*Re: Streetscape Redesign – Broadway / Main Street / Third Street  
Community Meeting April 29, 2021*

CRA Street Redesign  
Broadway / Main Street / Third Street  
Community Meeting April 29, 2021

Broadway / Main Street / Third Street  
Response to MITICMO Comment Letter

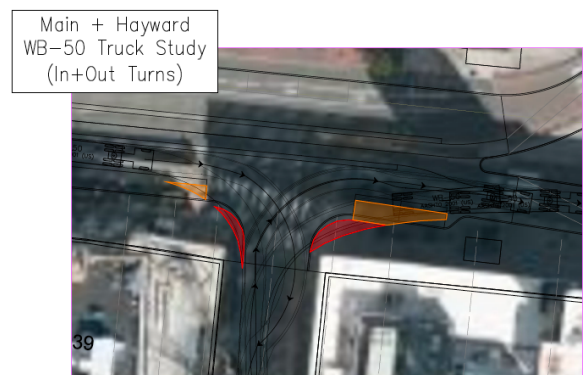
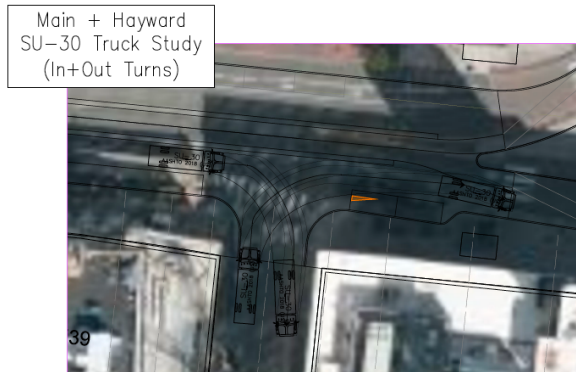
1. This option eliminates parking and drop off on the entire south side of Main Street except west of Ames St. (where there is no retail). Retaining some parking and short-term loading adjacent to the retail between Ames Street and Wadsworth Street is critical for the retail to survive. MIT does not support this option.

*Like MITIMCO, the CRA and the City of Cambridge want retail to succeed on Main Street. Kendall Square's success has grown as a multi-modal, transit-oriented development. The CRA and the City do not feel that parking is as vital to retail success at this location as broader multi-modal access, especially pedestrian clientele, but recognize the emerging/growing need for pick-up locations for food vendors. Most of the retail on Main Street survived a few years back before the SOMA redevelopment despite the street's closure to vehicles during Main Street's reconstruction and the Longfellow Bridge closure.*

*Unlike other options for Main Street, Option 1 - Side Bike Lanes removes parking and pick-up/drop-off areas on the south side of Main Street, and we recognize that MITIMCO does not prefer this option for that reason. There is a fair amount of off-street parking available nearby, especially for evening hours. The CRA acknowledges that pick-up and drop-off operations are recognized as a growing transaction*

*format for retail. Likewise, the number of shuttle buses running on both sides does create more conflicts for this option.*
